## MEMORANDUM

**SUBJECT:** **OP Report** –Request for a Modification of Consequence to approved PUD 16-02 at 1711 1<sup>st</sup> Street, SW

Item	Approved PUD	Proposed PUD Modification	Plans Sheet #
Mechanical Screening	Anodized aluminum perforated metal	HDPE	Sheet 3.15

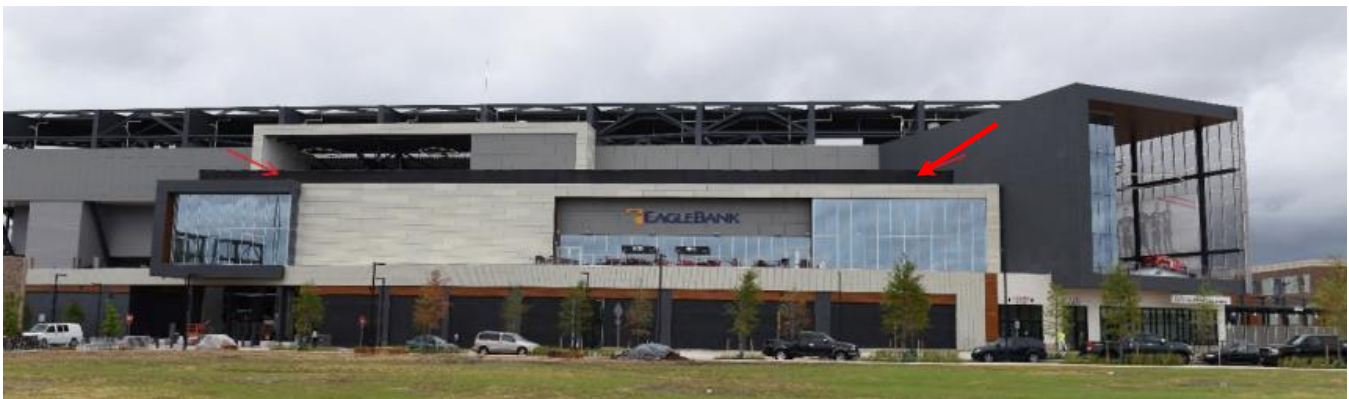
In summary, the applicant is proposing to modify the approved PUD by using black heavy duty knitted high density polyethylene (HDPE) for mechanical screening in place of anodized aluminum perforated metal on the roof of the stadium building (east elevation).

The perforated metal screen has been used else at the stadium (Exhibit 2D). While the perforated metal screen does not completely obscure the mechanical equipment, the lighter color and punched metal recedes in to the building behind and echoes the use of perforated metal elsewhere on the stadium. OP is not opposed to the use of HDPE for screening at this location as it more effectively hides the mechanical equipment, even though the HDPE reads as an opaque black band at the top of the building that changes the appearance of the east façade.
